UNITED STATES PATENT AND TRADEMARK OFFICE

APPLICATION NO.	FILING DATE	FIRST NAMED INVENTOR	ATTORNEY DOCKET NO.	CONFIRMATION NO.
10/615,407	07/09/2003	Phillip M. Santisi	8106.002.US	7945

Office Action Summary

FIG. 5

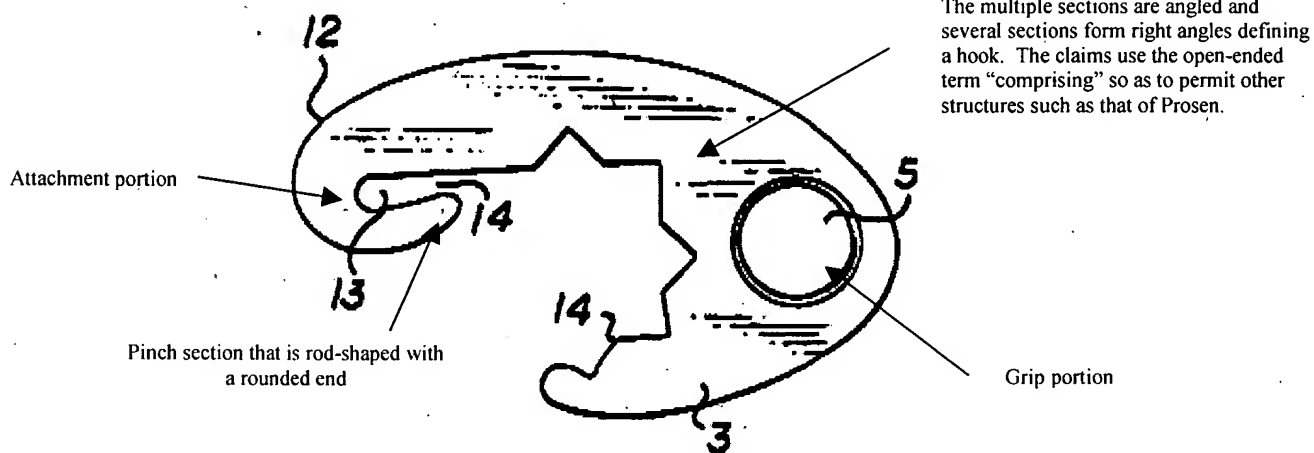
Prosen (figure 5) teaches a clasp 3 comprising a hook portion, a grip portion and an attachment portion, the hook portion comprising a first section, a second section and a third section, wherein the first section is connected to and perpendicular with the second section, the second section connected to and perpendicular with the third section.

Prosen utilizes fabric-jacketed elastic cords, which is inherently a bungee cord, to secure loads such as cargo to vehicle racks wherein the configuration of the hook portions are adaptable to securement to a variety of surfaces such as polygonal, cylindrical and irregular surfaces. As applicant has indicated that claim 1 is generic to the clasp of figure 5 of applicant's drawings, the claim construction appears to permit non-perpendicular portions in the same manner as applicant's figure 5 has non-perpendicular sections. As to claims 6-8, these relative dimensions are formed by sections of the hook portion of Prosen's device. In regard to claim 9, figure 6 of Prosen shows the hook portion in a single plane. As to claim 10, figure 5 shows that it is possible to configure planes perpendicular to the plane of the paper and aligned with the first and third sections. In regard to claim 11, the claims utilize the open-ended language "comprising" and the pinch section identified above is rod-shaped with a rounded end so as to meet the claim language while permitting other structure. As to claim 15, the pinch section identified above is between and therefore separates the grip portion from the attachment portion. In regard to claim 16, the pinch section identified above pinches the cord and therefore keeps that portion of the cord from entering the grip portion 5. As to claim 18, cargo is considered equipment for a purpose. In regard to claim 21, as pointed out above there are multiple straight angled portions connected together to form a hook portion.

FIG. 5

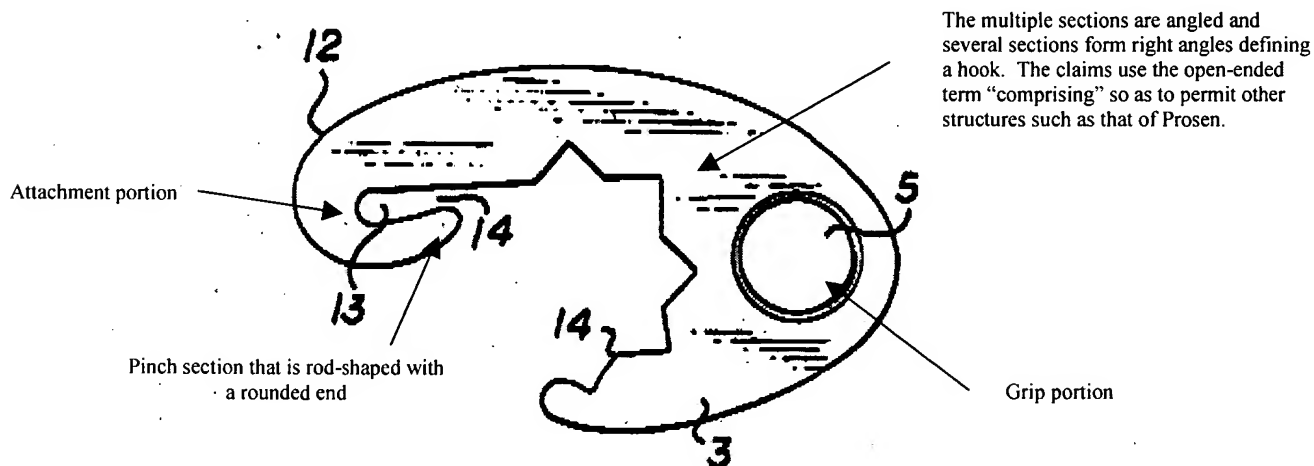
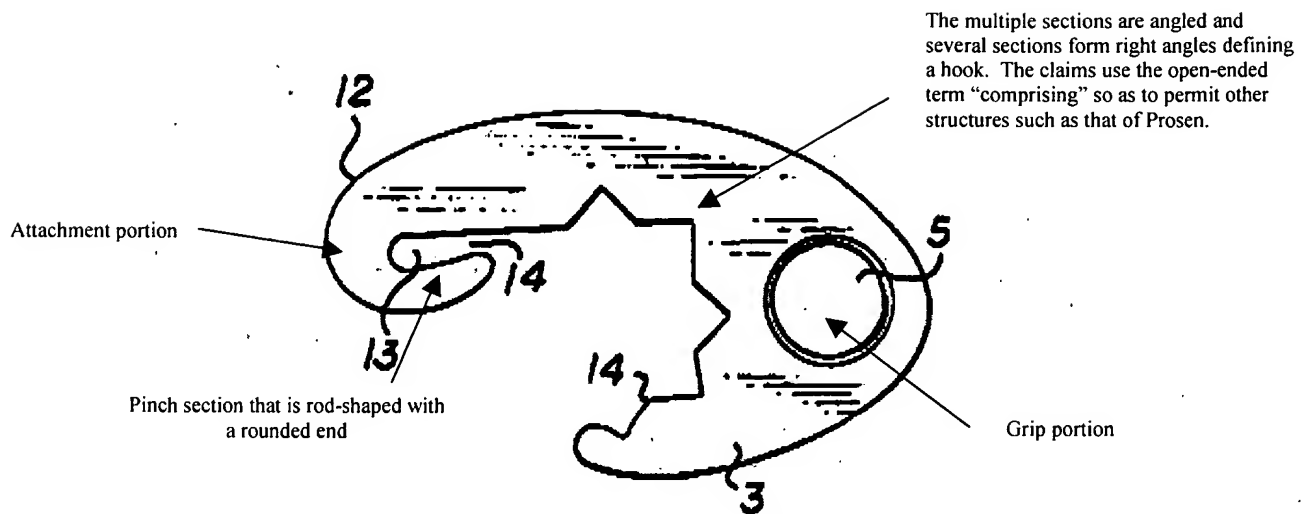
Prosen (figure 5) teaches a clasp 3 comprising a hook portion, a grip portion and an attachment portion, the hook portion comprising a first section, a second section and a third section, wherein the first section is connected to and perpendicular with the second section, the second section connected to and perpendicular with the third section.

Prosen utilizes fabric-jacketed elastic cords, which is inherently a bungee cord, to secure loads such as cargo to vehicle racks wherein the configuration of the hook portions are adaptable to securement to a variety of surfaces such as polygonal, cylindrical and irregular surfaces. The difference with regard to claim 2 is that the hook of figure 5 is an intermediate hook rather than being found at the ends of the cord. However, Chuan (figures 1-3, 5, 7) teaches that it is desirable to secure clasps with grip portions at the ends of the cord without intermediate hooks wherein there are reduced gaps in the attachment portions that would pinch the cord in a similar

manner to that of Prosen. As Prosen teaches that it is desirable to configure the hook portion with perpendicular portions for both the end hooks and the intermediate hooks and Chuan teaches that it is desirable to secure clasps with grip portions at the ends of the cord without intermediate hooks wherein there are reduced gaps in the attachment portions that would pinch the cord, it would have been obvious to modify the end hooks of Prosen so as utilize hooks with a pinching portion at the ends as taught by Chuan while maintaining the perpendicular sections taught by Prosen since Prosen wishes to keep the angular hook portion because of its greater use in securing the clasp to various shapes. As to claim 5, the devices of Prosen and Chuan describe the typical bungee cord that is well known. In regard to claim 22, this claim is rejected for the reasons identified for claim 2 with the further observation that the pinch section identified above with respect to Prosen pinches the cord and therefore keeps that portion of the cord from entering the grip portion 5. As to claims 12, 13, 27 and 28, Chuan teaches that the use of steel is conventional for forming the hooks as would be expected because of its strength (col. 1, lines 19-25).

FIG. 5

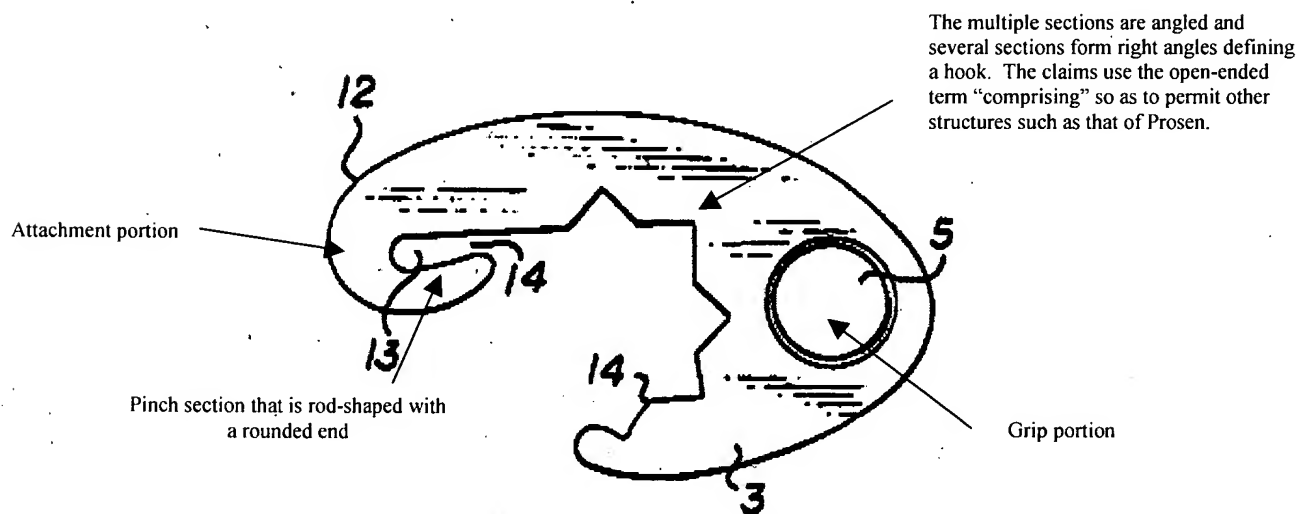
Prosen (figure 5) teaches a clasp 3 comprising a hook portion, a grip portion and an attachment portion, the hook portion comprising a first section, a second section and a third section, wherein the first section is connected to and perpendicular with the second section, the second section connected to and perpendicular with the third section.

Prosen utilizes fabric-jacketed elastic cords, which is inherently a bungee cord, to secure loads such as cargo to vehicle racks wherein the configuration of the hook portions are adaptable to securement to a variety of surfaces such as polygonal, cylindrical and irregular surfaces. The difference is that the first section doesn't separate the grip portion from the second and third sections of the hook portion. Relocation of the grip portion of the device of Prosen so that the

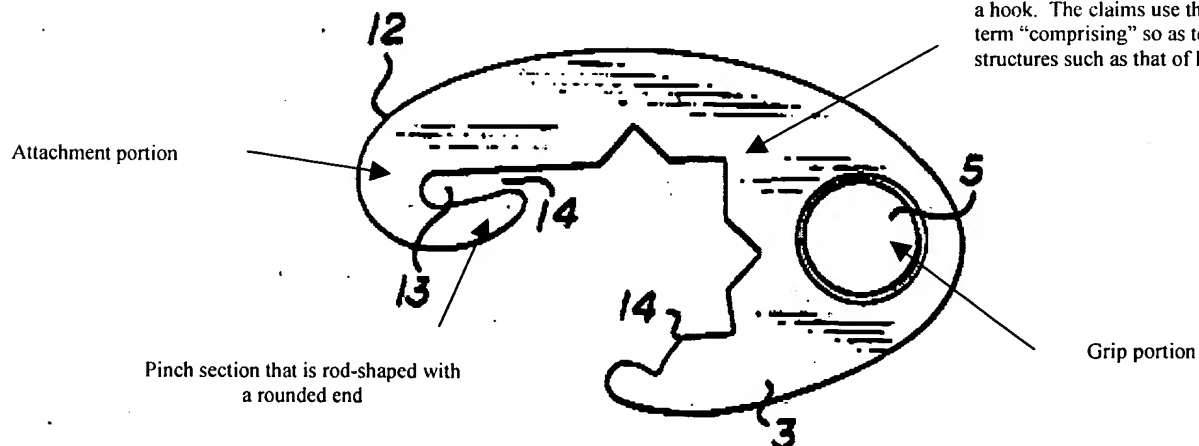
first section separates the grip portion from the second and third sections of the hook portion would have been obvious in view of Yonts (figures 2, 3) teaching placing the grip portion 10 so that the first section separates the grip portion from the second and third sections of the hook portion so as to provide a useful way to apply force to attach the hook portion.
